STATE HIGHWAY 105 / JACKSON CREEK PARKWAY - PHASE 2

CONSTRUCTION PLANS

Comments provided by DPW Capital Projects

CCES RESPONSES

TYPICAL HOT MIX ASPHALT PAVEMENT LIFT SECTION

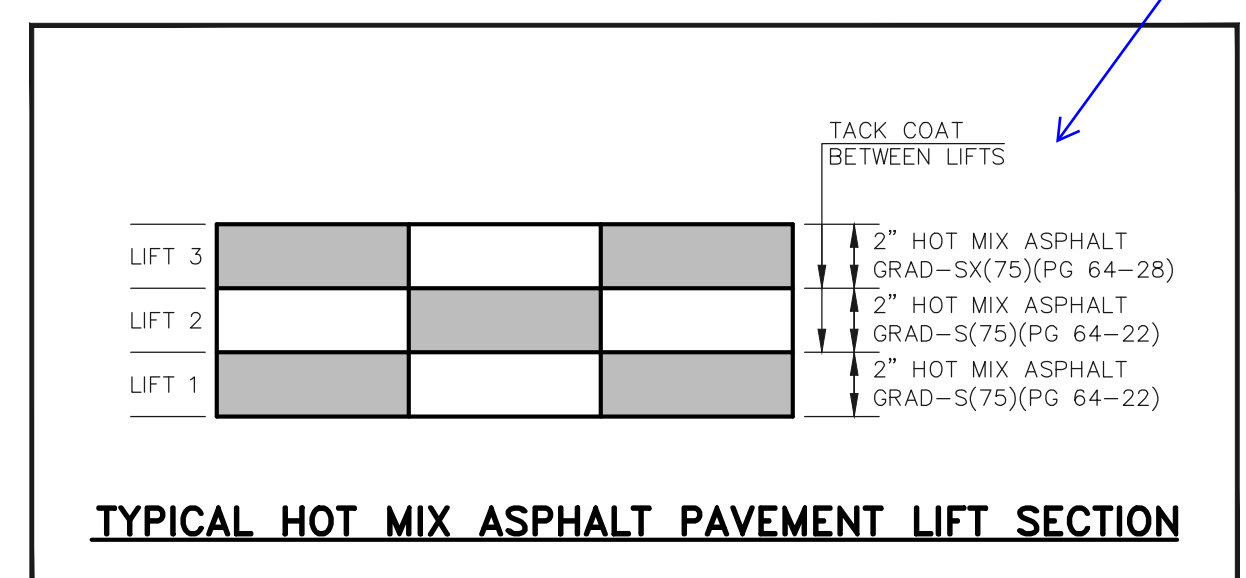
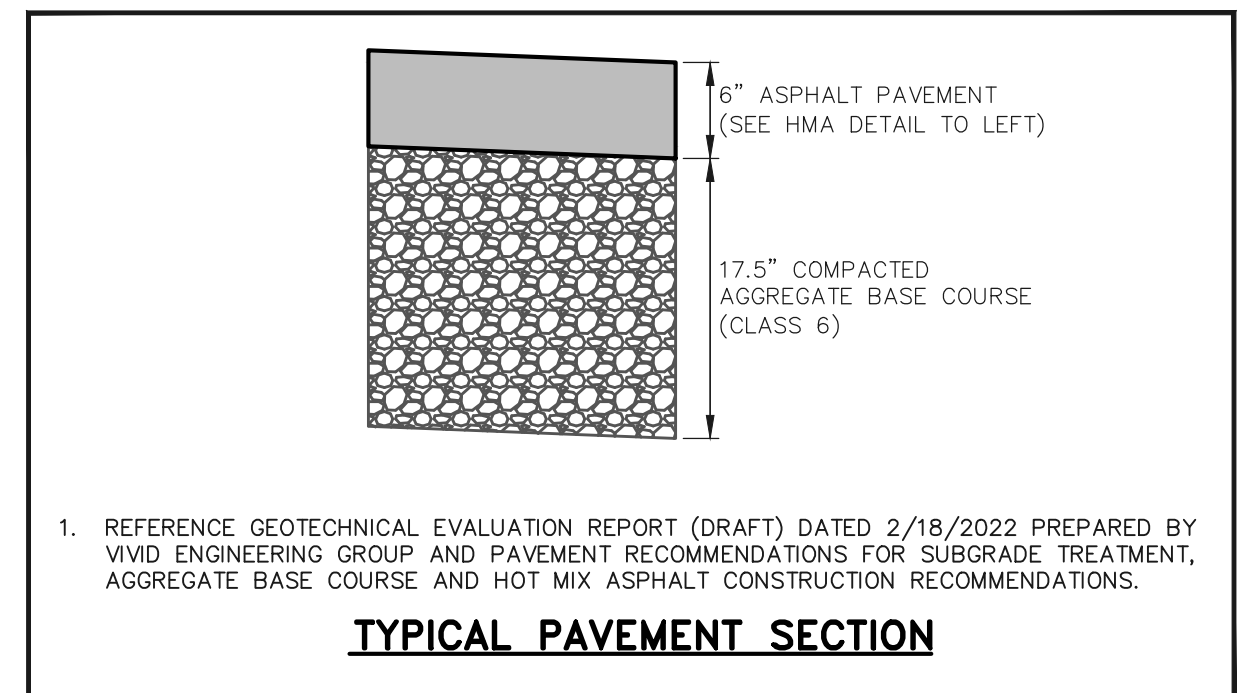
Asphalt lift is different than previous sheets. Please revise to same detail or clearly state where different lift sections are happening within plan.

THERE IS A DIFFERENT PAVEMENT DESIGN FOR JCP VS. HWY. 105. NOTE NOW ADDED TO EXPLAIN.
